Access Compliance Report

Public Rights-of-Way

Intersection ID: 8673	Main Street: ROWAN_ST	Cross Street: TILLMAN_RD	Location: NE
ADA ID: 75E2459A3D0D	Ramp Type: Perp	Initial Pass/Fail: Fail	Overall Compliance: No
		Severity Score: 1.25

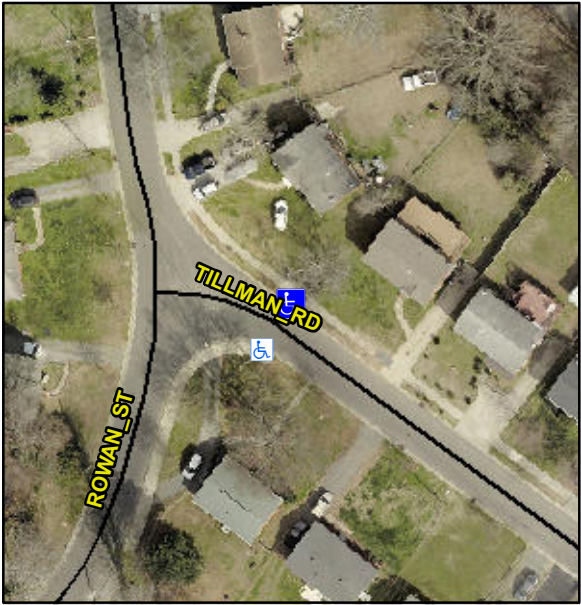
Codes/Mitigation Info/Possible Solution			Field Measurements/Component Compliance		
	Possible Solutions:		Compliance	Description	Data
	Remove & Replace Entire Ramp.		Yes	Ramp Length (in)	47.5
			N/A	Ramp Width (in)	48.0
			N/A	Flare Type LT	N/A
			N/A	Flare Slope LT (%)	N/A
			N/A	Flare Traversable LT?	N/A
			N/A	Flare Traversable RT?	N/A
			N/A	Landing Length (in)	N/A
			N/A	Landing Width (in)	N/A
			N/A	Landing Slope (%)	N/A
Surveyor Notes: N/A PROW/ADA: Not Found, R304.5.3			N/A	Landing X Slope (%)	N/A
			N/A	Landing Curb? (Y/N)	N/A
			N/A	Shared Landing?	N/A
			N/A	Gutter Ponding?	N/A
			N/A	Gutter Lip Ht (in)	N/A
			N/A	Painted X Walk1?	No
			N/A	X Walk 1 Direction	To SW
			N/A	X Walk 1 Width (in)	N/A
			N/A	X Walk 1 Slope (%)	2.9
			N/A	X Walk 1 X Slope (%)	3.2
Total Cost: \$ 1850.00			N/A	Ramp inside XWalk1?	N/A
			N/A	Road Slope (%)	N/A
			N/A	Road X Slope (%)	N/A
			N/A	Any Obstructions?	N/A
			N/A	Obstruction Type
